Re: Watson Cogeneration Steam and Electric Reliability Project
Application for Certification 09-AFC-1

RESPONSES TO JUNE 15, 2011 CEC DATA REQUESTS APPLICATION FOR CERTIFICATION (09-AFC-1) for Watson Cogeneration Steam and Electric Reliability Project

Responses to June 15, 2011 CEC Data Requests

Figure 5.5-1 (Second Revision) Water Balance Flow Diagram

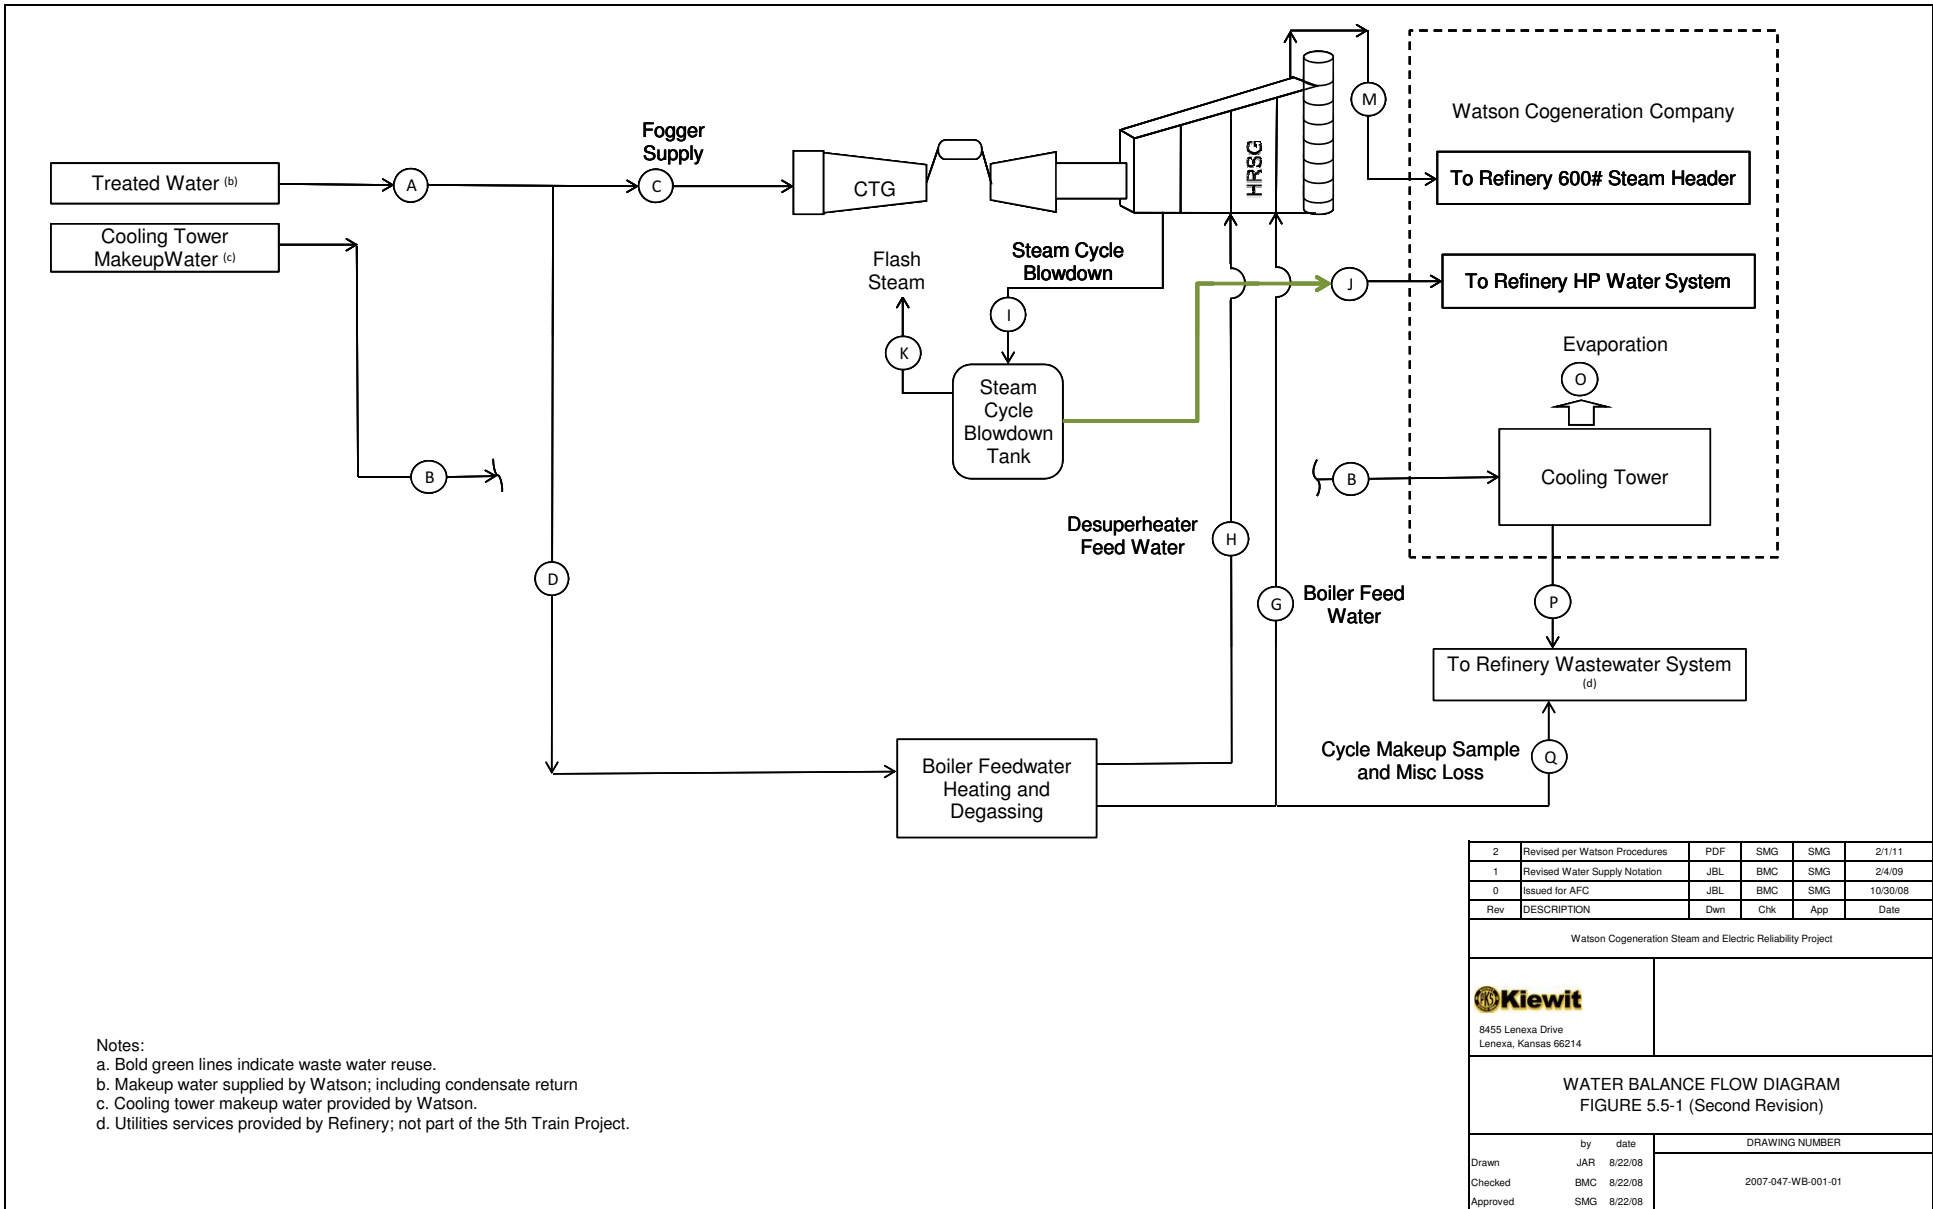
- 1. Please provide updated versions of Table 5.5-4 and Figure 5.5-1, Water Balance Flow Values and Diagram included in the updated AFC section provided in the March 28, 2011 workshop response that reflect the condensate return in the water balance for the fifth train. Please breakdown how much of the 2,286 AFY of treated water and 439 AFY of cooling tower make up, or the revised values, are comprised of freshwater and condensate return.*

- Please provide updated versions of Table 5.5-4 and Figure 5.5-1, Water Balance Flow Values and Diagram that reflect the condensate return in the water balance for the fifth train for the future reclaimed water scenario. Please breakdown how much the 2,855 AFY of first pass reverse osmosis treated reclaimed water and 160 AFY of nitrified reclaimed water cooling, or the revised values, would be reduced by condensate return.*

Figure 5.5-1 (Second Revision) from the Applicant's March 2011 Revised Section 5.5 (Water Resources) already incorporates condensate return, so it has not been revised, although it has been re-printed within this document for convenient reference.

Figure 5.5-1 (Second Revision, which was filed within the Applicant's March 2011 Revised Section 5.5 Water Resources) already reflects the condensate return. Consequently, no revision is necessary. For convenient reference, this figure has been re-printed in the Applicant's response to Data Request 1.

Watson Cogeneration Facility
Simplified Water Delivery Diagrams
 Watson Cogeneration Steam and Electric Reliability Project
 Figure 7-1

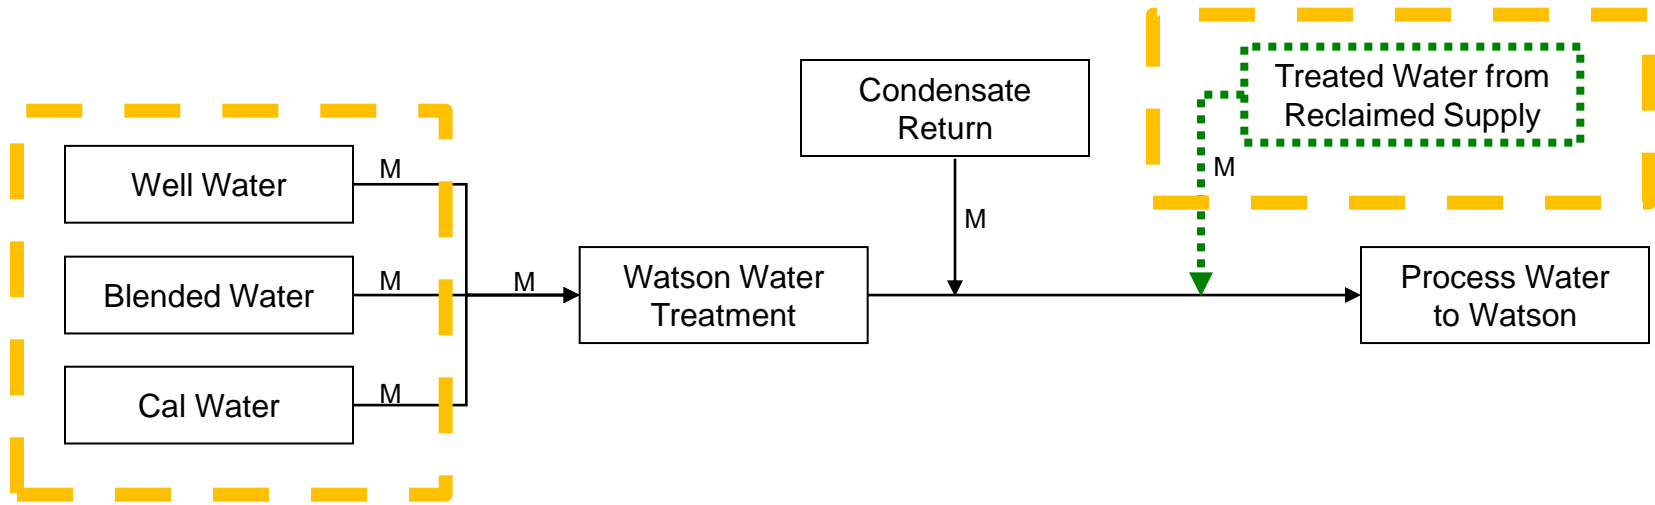
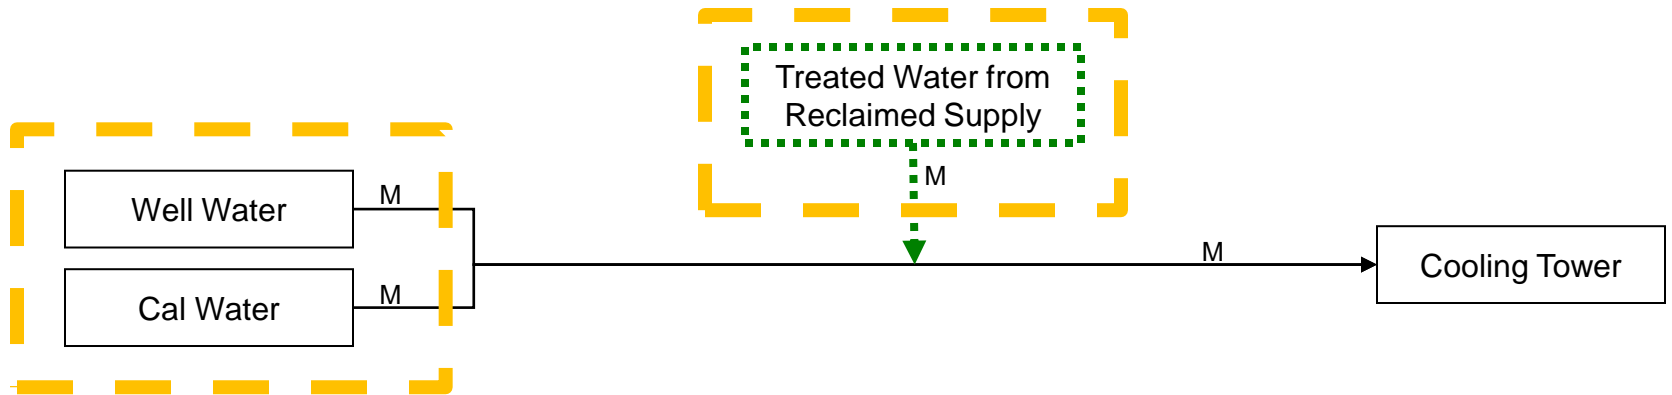
7. *Please describe how water use will be accounted for, measured, and reported for the combined five trains to ensure that water use from non-reclaimed sources does not exceed the cap.*

Non-reclaimed water is currently supplied to the Watson Cogeneration Facility via three supply lines: Well Water, Blended Water, and Cal Water. Water delivered to the Watson Cogeneration Facility from each of the three water supply lines is metered. Figure 7-1 presents simplified water delivery diagrams for the process water supply to the Watson Cogeneration Facility and for the cooling tower makeup water supply to the Watson Cogeneration Facility cooling towers.

As the Applicant noted in their response to Data Request 48 filed in January 2010, the Applicant has agreed to file with the CEC an Annual Water Use Summary which will include total usage for each water supply (reclaimed, Cal Water, and Well Water) for the five-train Watson Cogeneration Facility.
